## **DUNNAM ESTATES SUBDIVISION**

APPLICATION NUMBER 28 DATE March 6, 2008

REQUEST Subdivision

# DETAIL SITE PLAN

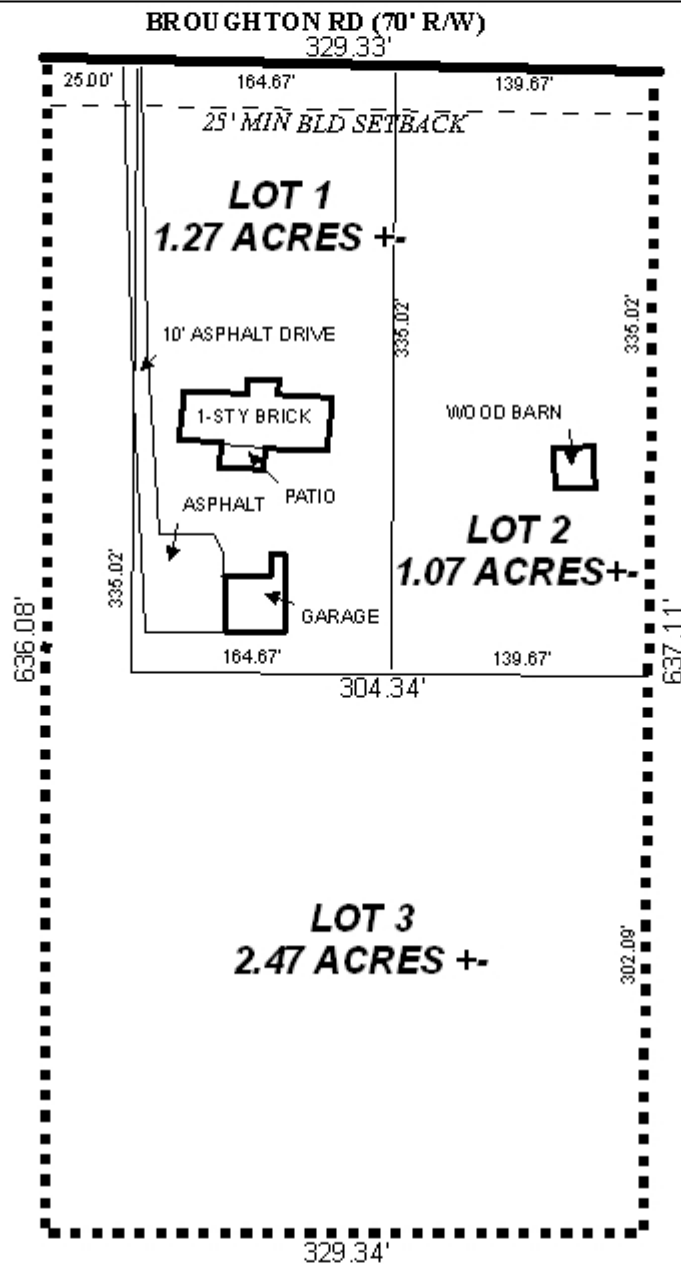
According to the plat submitted, the applicant agrees to a total of two curb cuts for the proposed 3 lot subdivision. If approved, there should be a note on the final plat stating that lots 1, 2 and 3 are limited to a total of two curb cuts.

Proposed lot 3 appears to be a flag lot which will have a "pole" connecting it to Broughton Road. A precedence has been set for flag lots in the vicinity, however, because of the limited frontage of proposed lot 3, no additional subdivision of the lot should be allowed until additional frontage on a public street is provided. If approved, which will require a waiver of Section V.D.3. of the Subdivision Regulations, the plat should be revised to depict the minimum building setback line of lot 3 to be at least 25' from where the "pole" meets the flag portion of the lot.

A note should be placed on the Final Plat stating that any lots which are developed commercially and adjoin residentially developed property must provide a buffer, in compliance with Section V.A.7. of the Subdivision Regulations.

Finally, the plat should be revised to label each lot with its size in square feet, in addition to the total acreage depicted on the plat.

- 1) Provision of documentation establishing the creation date of the parcel as prior to 1984, or that it is a legal lot;
- 2) Placement of a note on the final plat stating that proposed lots 1, 2 and 3 are limited to 2 total curb cuts, with the size, design and location to be approved by County Engineering;

- 3) Revision of the plat to depict the 25’ minimum building setback line from where the pole meets the flag portion of the lot;
- 4) Placement of a note on the plat stating that there shall be no additional subdivision of lot 3 until additional frontage on a public street is provided;

- 6) Placement of a note on the plat / site plan stating that the site must be developed in compliance with all local, state and Federal regulations regarding endangered, threatened or otherwise protected species;
- 7) Placement of a note on the final plat stating that any lots which are developed commercially and adjoin residentially developed property must provide a buffer, in compliance with Section V.A.7. of the Subdivision Regulations; and
- 8) Labeling of each lot with its size in square feet in addition to acreage.
